Report to the Future Melbourne (Planning) Committee

**Ministerial Planning Referral: TPM-2013-2
57-59 Haig Street, Southbank**

3 December 2013

PLANNING REPORT

East (Blakeney Place) Elevation

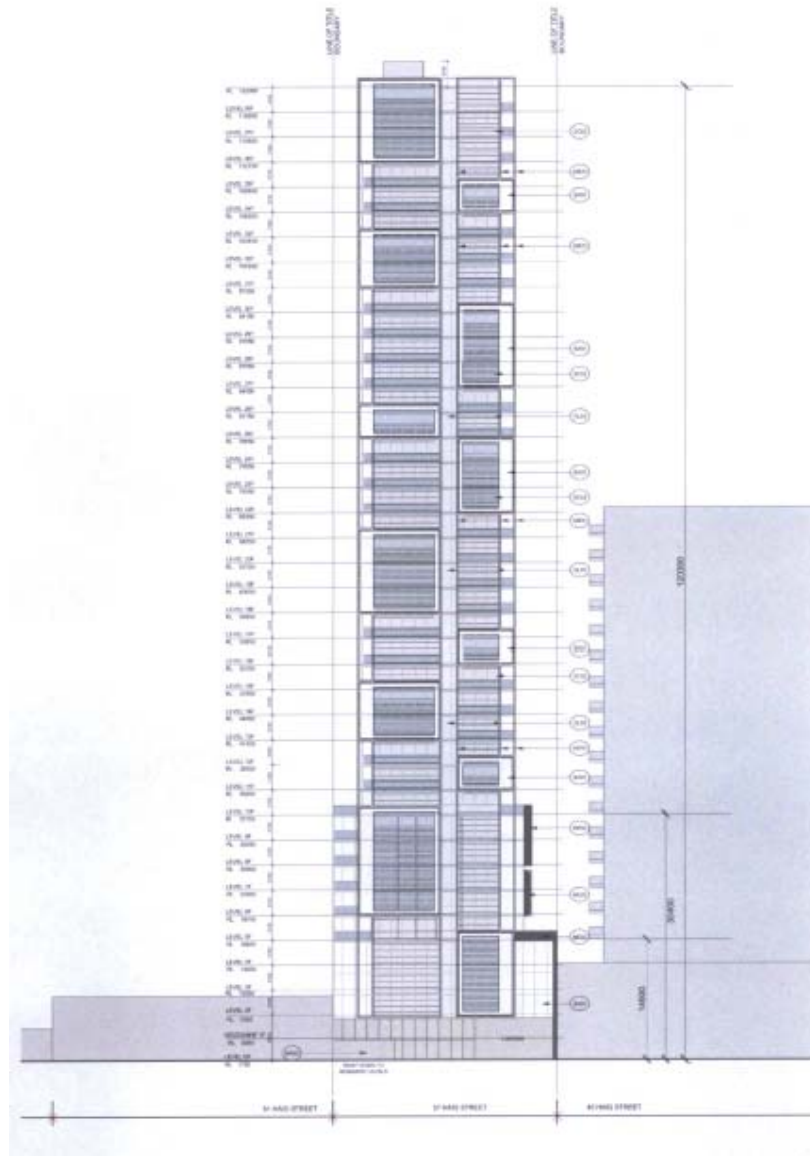
7. The proposed zero setback of the tower from Blakeney Place is considered insufficient as it would dominate the urban form at ground level and exacerbate the existing poor amenity of the lane. A condition requiring a minimum setback of two metres (measured to the balcony edges) to Blakeney Place is recommended to address this.

The subject building is proposed to be set back 2 metres from the rear boundary, however all balconies are proposed to be built to the rear boundary for the entire podium and tower, resulting in zero setback to the rear. Blakeney Place is a 6 metre wide laneway which provides vehicular access only into the subject site, the Urban Central Accommodation building to the rear and Clarendon Towers to the north-east. There are no pedestrian footpaths or access to buildings along this laneway.

The proposed zero setback does not provide for a considered response to the development potential for the neighbouring site to the rear.

- a. Provide a tower separation minimum of 10 metres for levels 6 to 10 from Clarendon Towers, measured from all balcony edges.
 - b. Setback the tower element (levels 11 to 22) a minimum of 2 metres from the rear (south-east) title boundary to Blakeney Place, measured from all balcony edges.

Levels 2 to 4

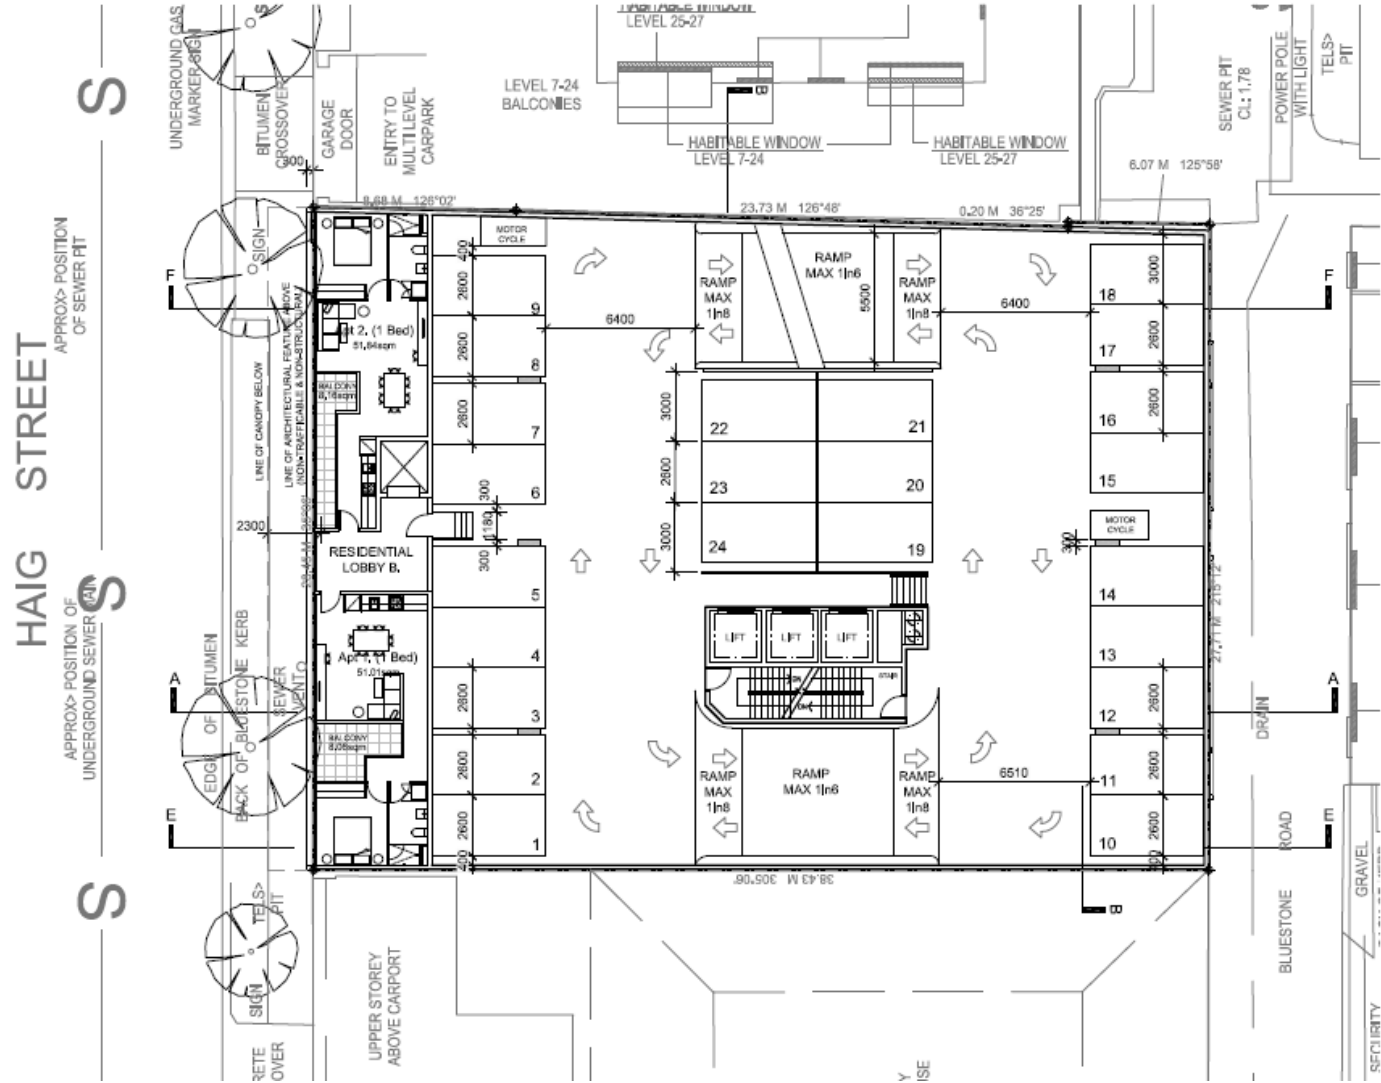
The amenity of the proposed apartments will generally be of an acceptable standard. All apartments have either a winter garden type indoor/outdoor area or a terrace with a minimum dimension of 8 square metres. Urban Design raised concern about the usability of the balconies of apartments 2 of levels 2F to 4F due to their awkward design. It is recommended that these balconies be redesigned to provide a more usable space.

- e. The balconies of Apartments 2 of levels 2F to 4F redesigned to provide a more usable outdoor space.
- f. Relocation of the communal areas from level 5 to the level 10 podium.

Level 10 - podium

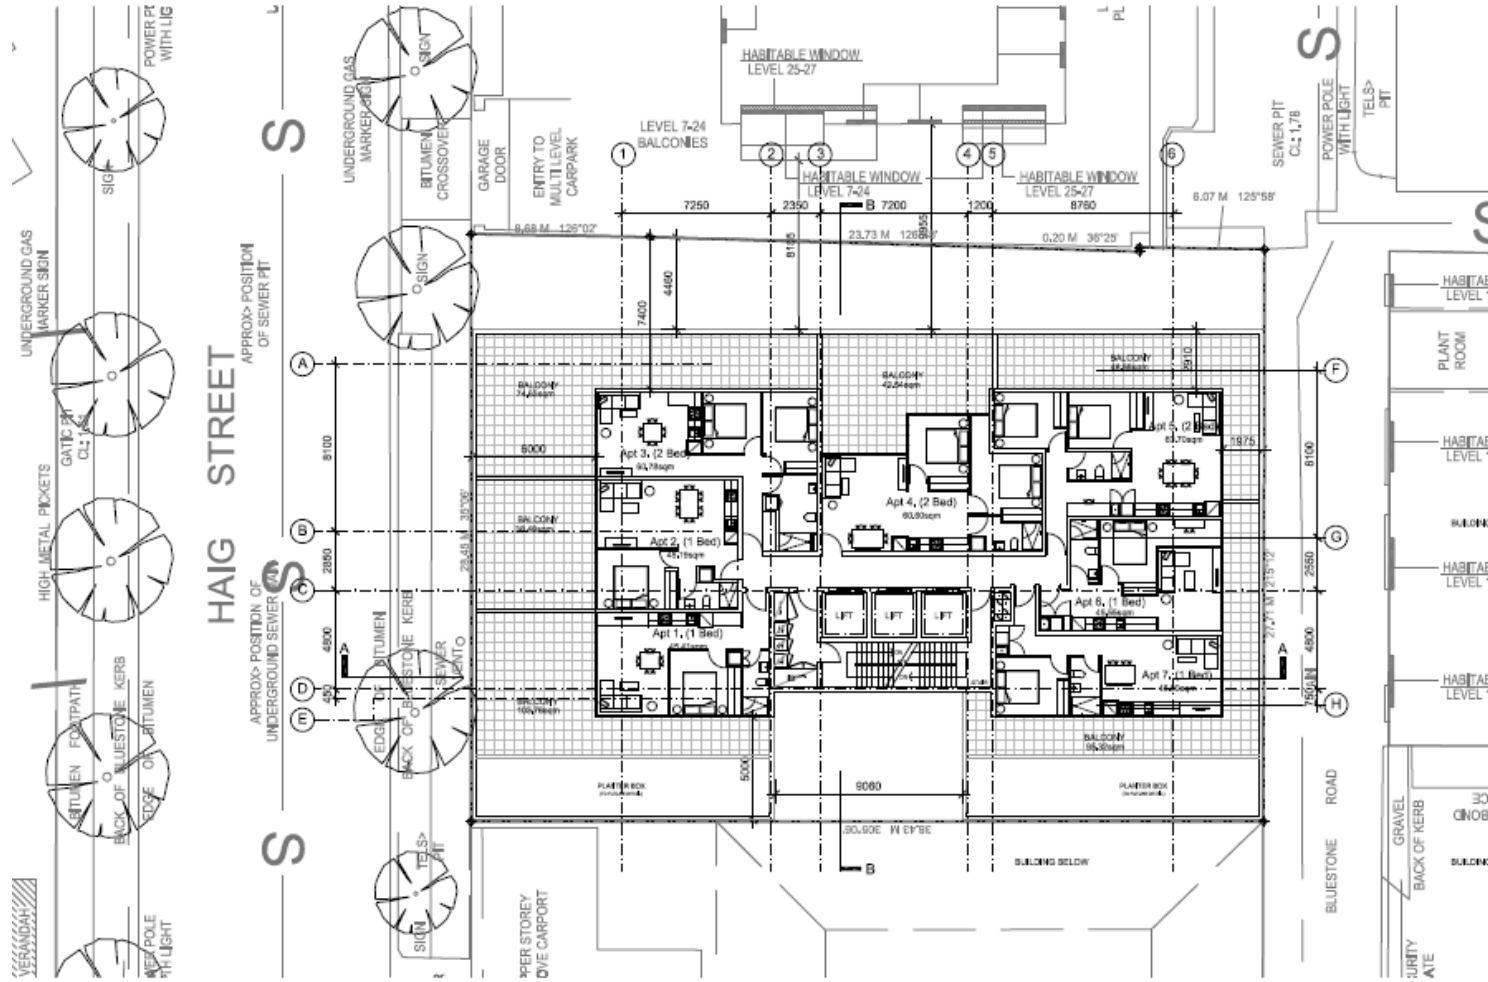
It is considered that there is a prime opportunity to provide communal open space at the level 10 podium, be it half of the level of all of the level. Level 10 provides for a more considered and appropriate area of open space which will allow for capitalisation of the northern light and views across Haig Street to increase passive observation of the street.

Tower setback from Clarendon Towers

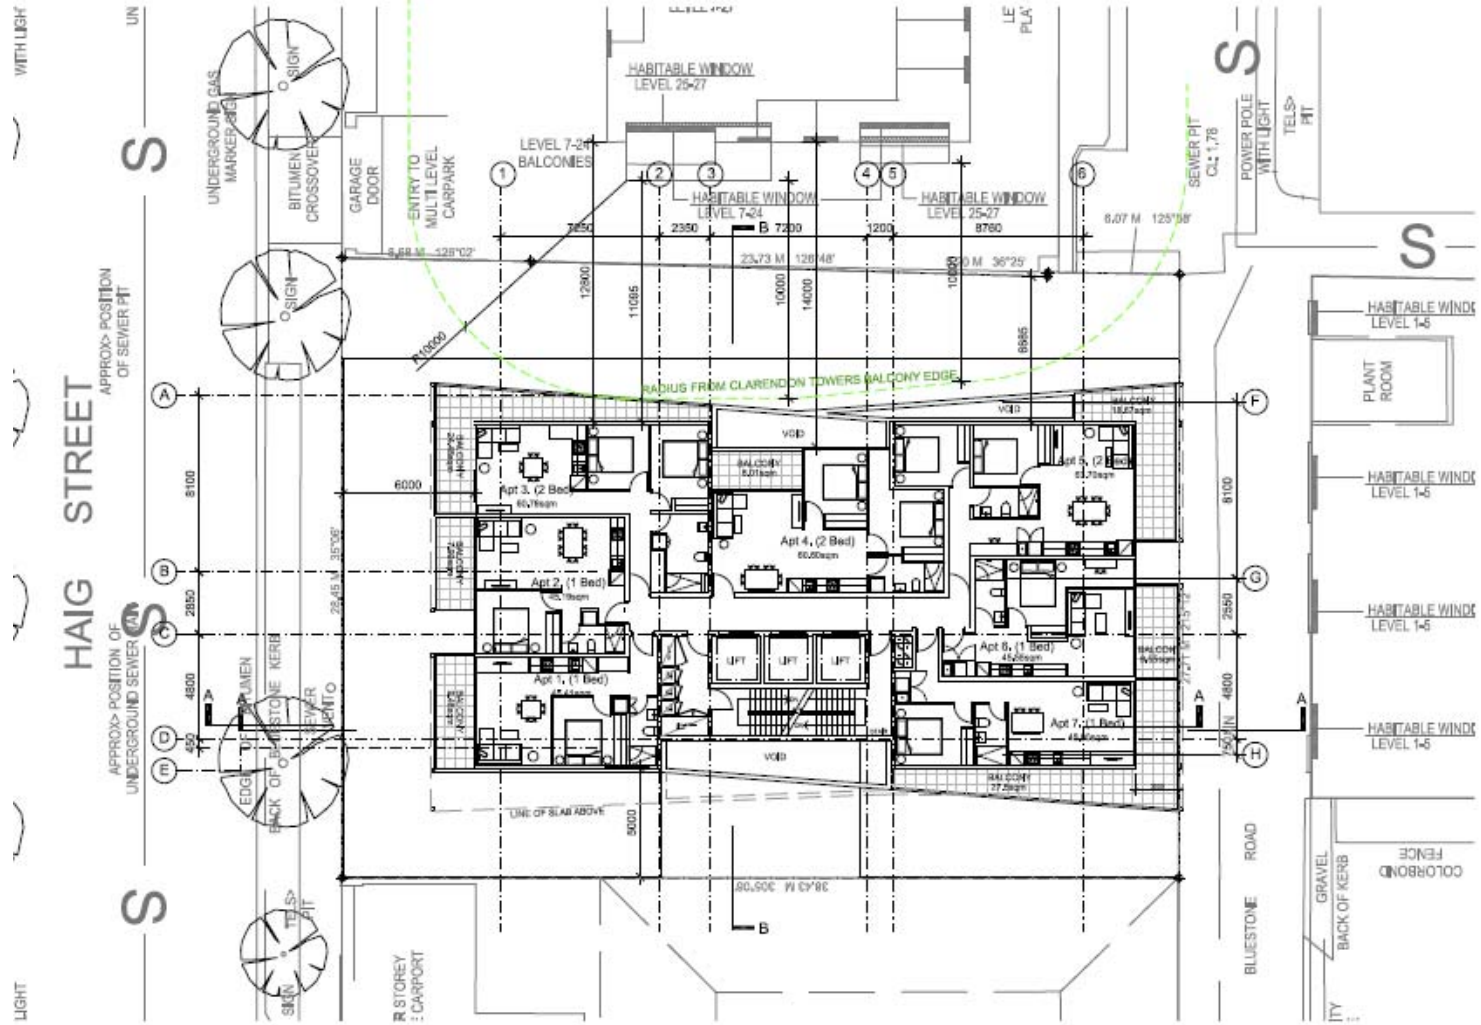
9. The proposed 7 metre tower separation between the subject site and Clarendon Towers for levels 6 to 10 is considered insufficient and would not provide an appropriate separation for the future occupants of the north-east facing apartments and the existing neighbouring Clarendon Towers residents. A condition is recommended requiring the provision of additional tower setbacks so as to maximise light, air and outlook for these apartments.

Concern is raised about the 7 metre tower separation for levels 6 to 10. The minimal setback will result in an unreasonable amenity impact for the future residents of the proposed development. Should a permit be issued it is recommended that this separation be increased to 10 metres to provide an appropriate and policy compliant tower separation between the subject site and Clarendon Towers.
